Mountain View Cemetery Expansion Project

Response to Comments / Final Environmental Impact Report

Lead Agency: City of Oakland

City Case # PCN15048 – ER01

Figure 10-1
Revised Project - Proposed Tree Protection Measures

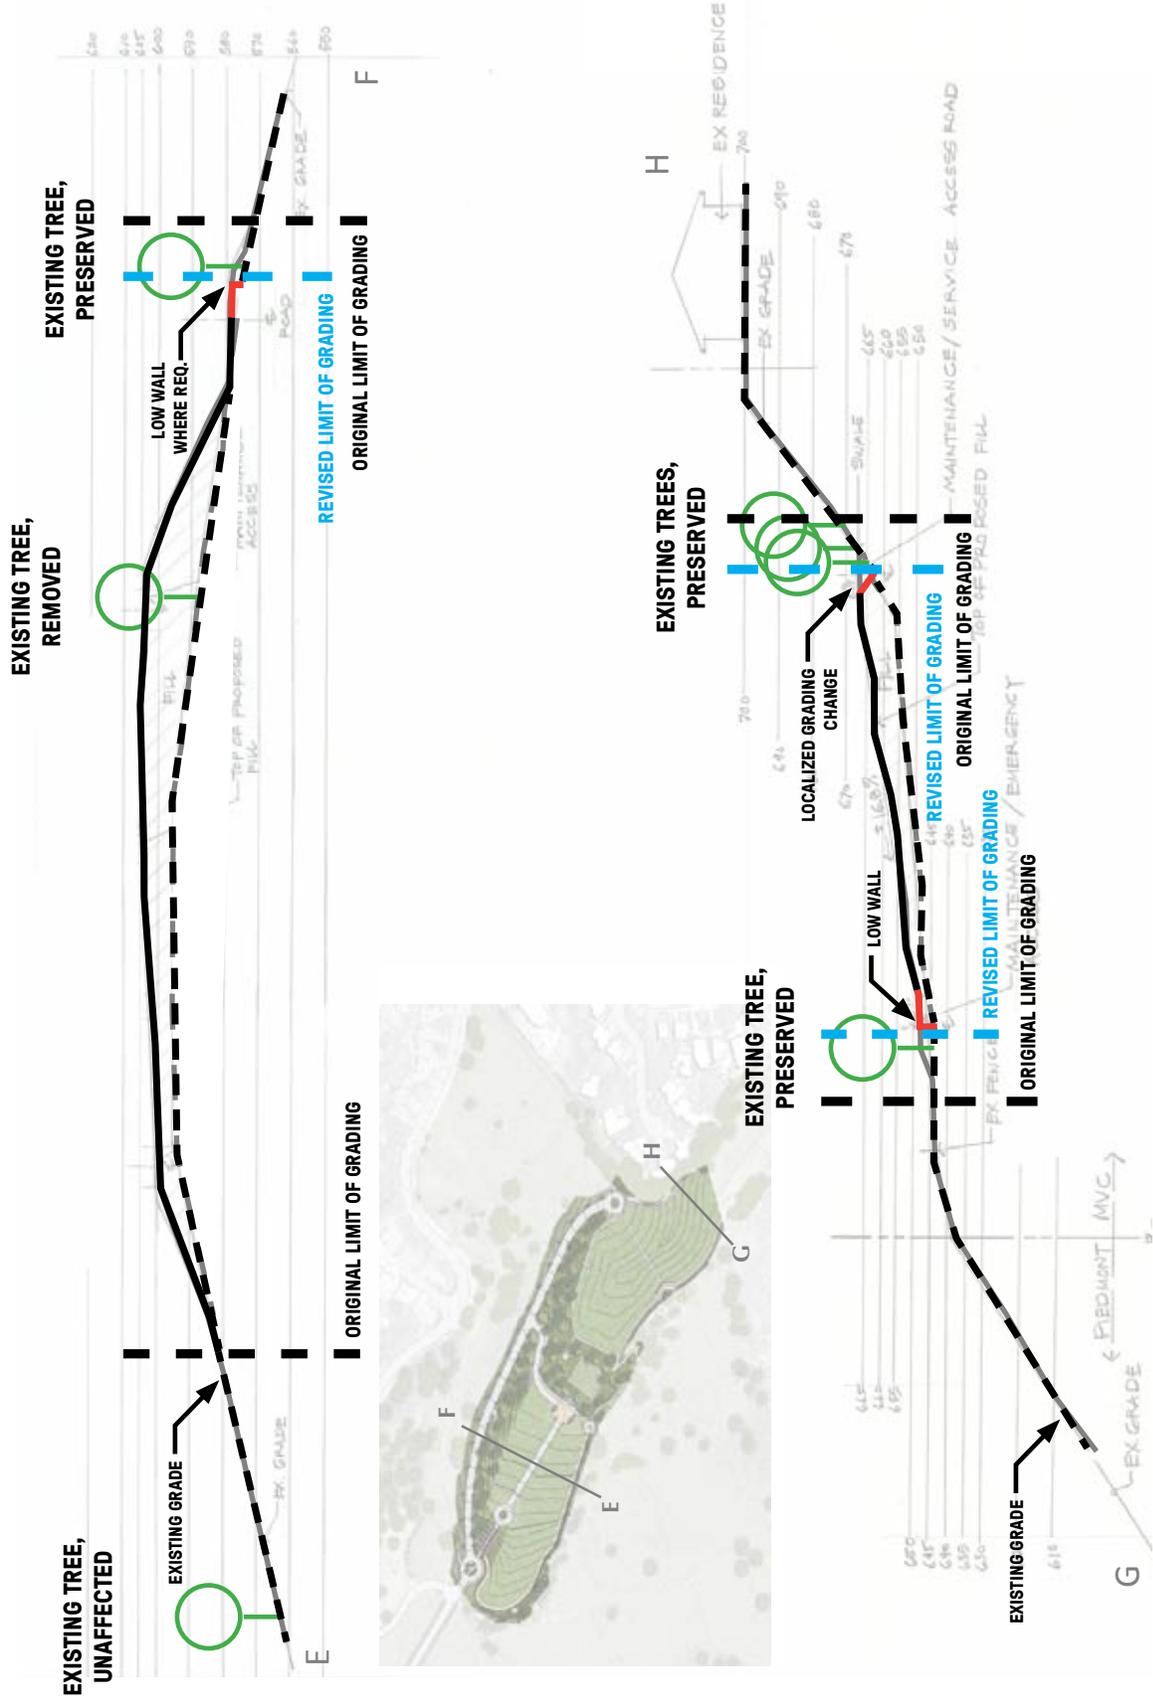
The Revised Project's proposed grading plan now includes specifically targeted tree protection measures that would occur along the exterior edge of grading operations, capable of protecting certain individual trees (primarily larger oaks) located along the outer edges of each proposed development site. These tree protection measures (see **Figure 10-1**) include:

- Incorporation of tree wells and short retaining walls constructed at the outside edge of tree canopies, holding back new fill from the base of certain trees to be retained;
- Feathering or sculpturing the edges of grading operations such that the limits of grading are pulled back from below the canopy of certain trees to be retained; and
- Lowering the height of fill against the Stark Knoll hillside by flattening the peak of fill outboard of the existing hillside face.

Figure 10-2
Revised Project Landscape Plan, Plot 82

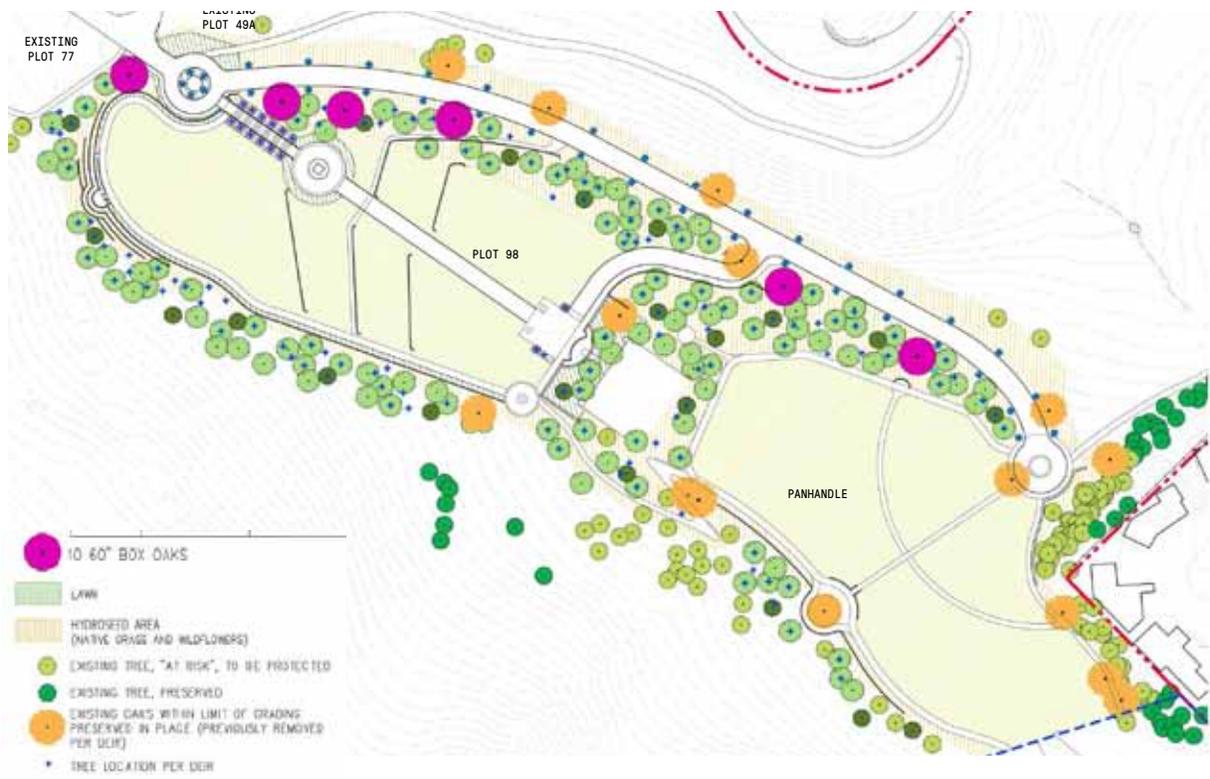
After considering public comments and staff recommendations, the Project applicant is also now proposing a revised landscaping plan pursuant to the Revised Project. This revised landscaping plan now includes the following key elements:

- The Cemetery will replace all removed Coast live oaks with replacement Coast live oaks on a 1:1 basis. This will result in 93 new, 24” box Coast live oaks planted within the Project site.
- As a replacement for the 34 non-oak, but protected trees to be removed, the Cemetery will provide for replacement planting also at a 1:1 ratio, using new, 24” box trees from the City-approved list of allowable replacement tree species. These may include Coast live oak, Canyon live oak, Mesa oak, Island oak, and Coast redwoods, California buckeye, Oregon white oak, California black oak and/or Valley oak.

The Revised Project’s Landscape Plan is shown on **Figure 10-2 and 10-3**.

Figure 12-2
Revised Project - Additional Tree Protection
Plot 82

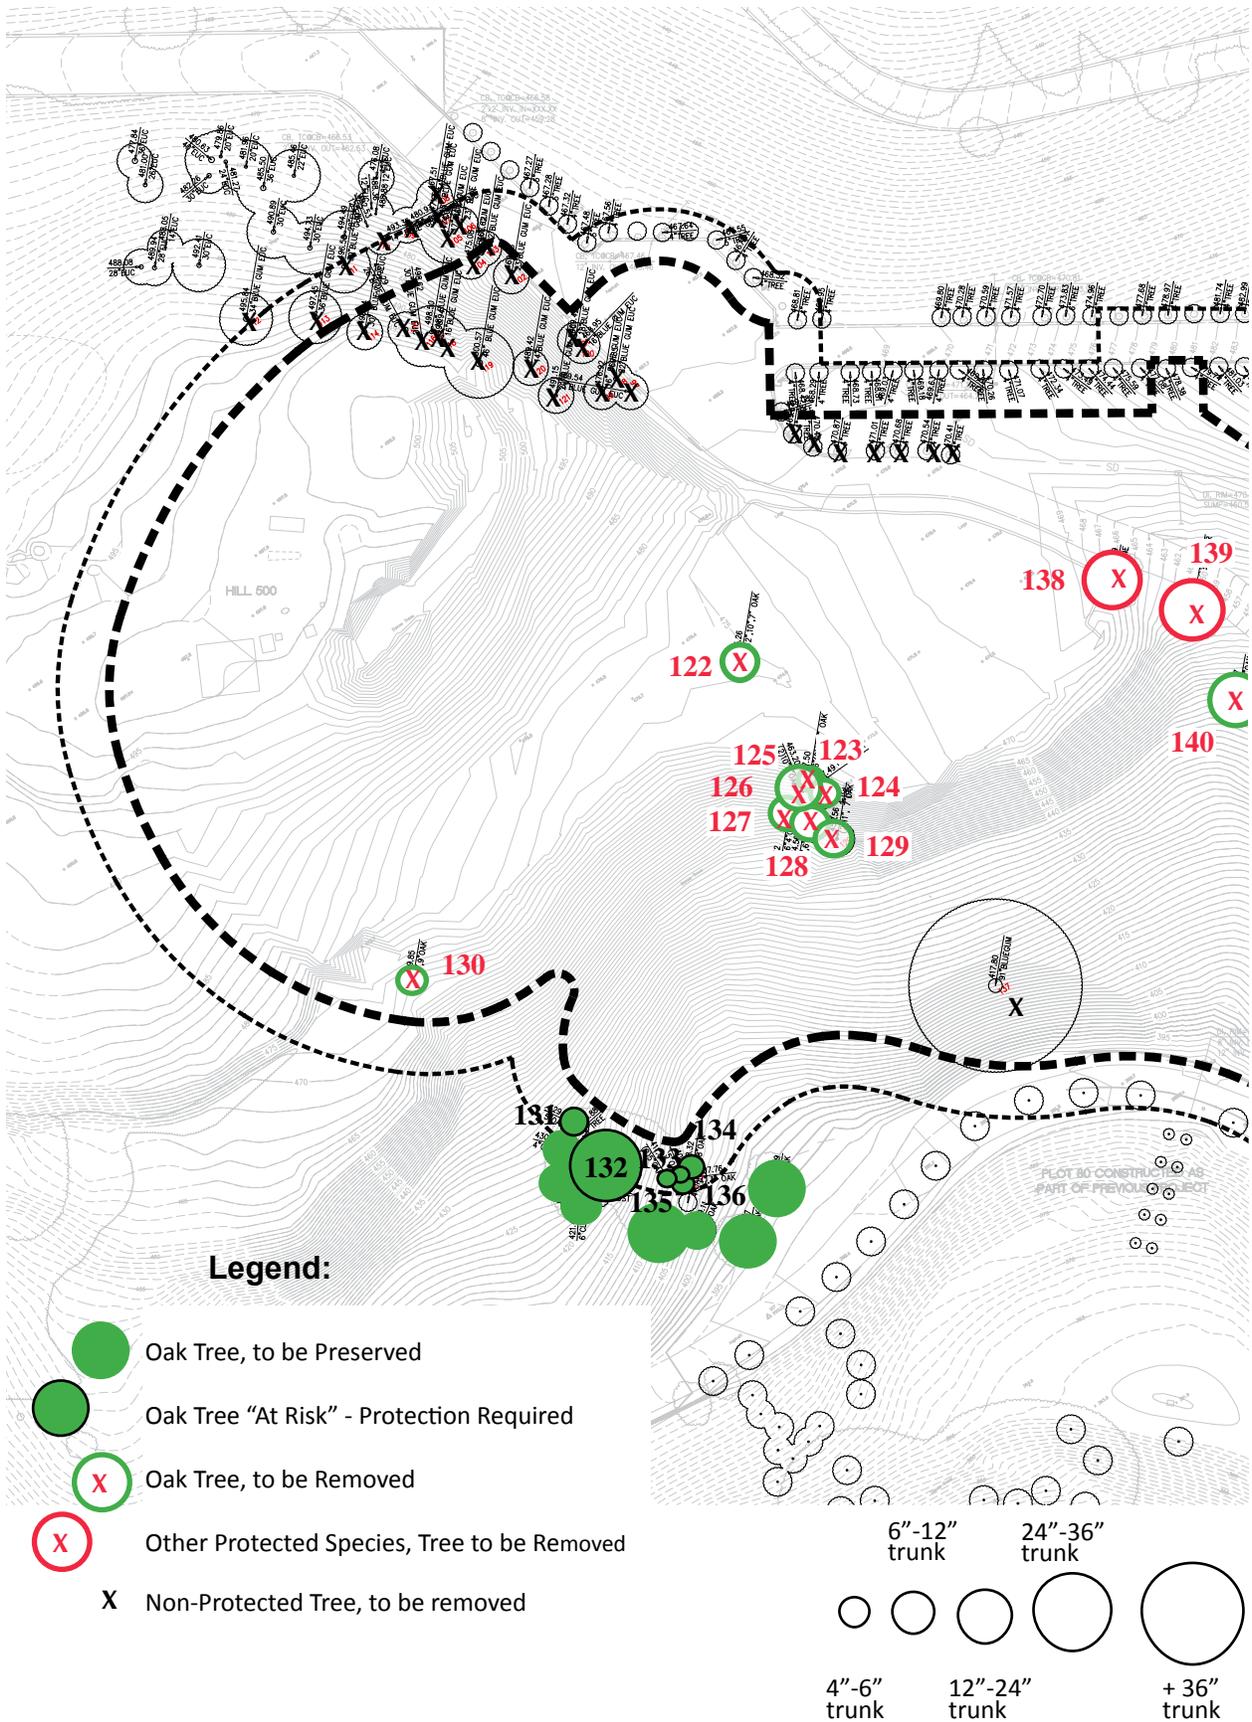
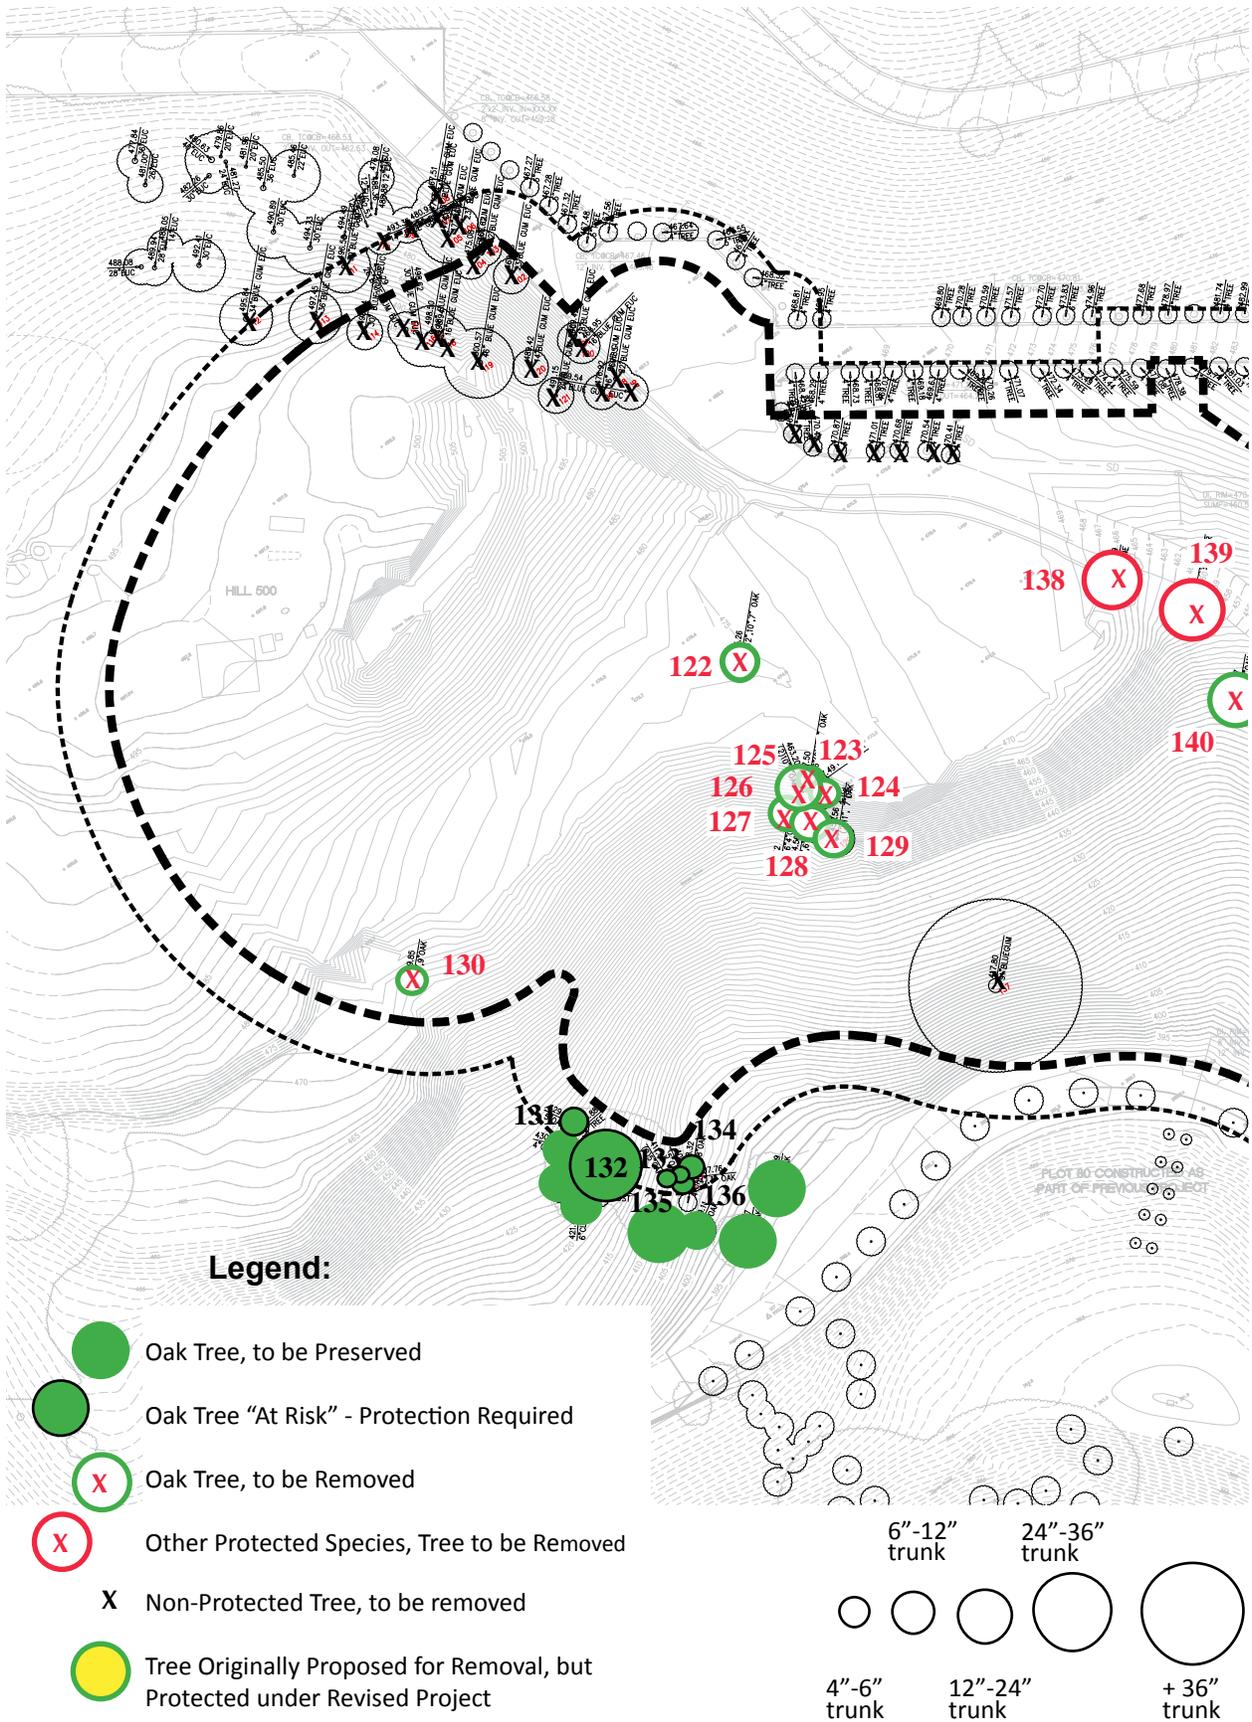
At the terminus of the retaining/crypt wall in the westerly portion of Plot 82, the applicant has found it not feasible to reduce the extent of cut below the existing Plot 77 slope, as this cut is necessary for construction of the new road. Oak trees #184 and 185 are directly affected by this roadway alignment. However, up-slope from this new roadway alignment, the Revised Project does indicate that an additional existing oak tree - #179, can be retained and protected in addition to the cluster of other oak trees in this area (#s 180-183, 186) that have been identified as “At Risk” (not removed).

At the area immediately adjacent to and upslope from the new roadway’s intersection with the existing roadway below Plot 82, the Revised Project design specifically seeks to retain as many oak trees within the tree cluster as possible. In addition to those trees identified in the Draft EIR as being “At Risk” and in need of protection measures (trees # 195, 207-215, 217 and 218), the Revised Project now indicates that three additional trees in this area (trees # 203, 204 and 206) will also be retained with a slight realignment of the new road.
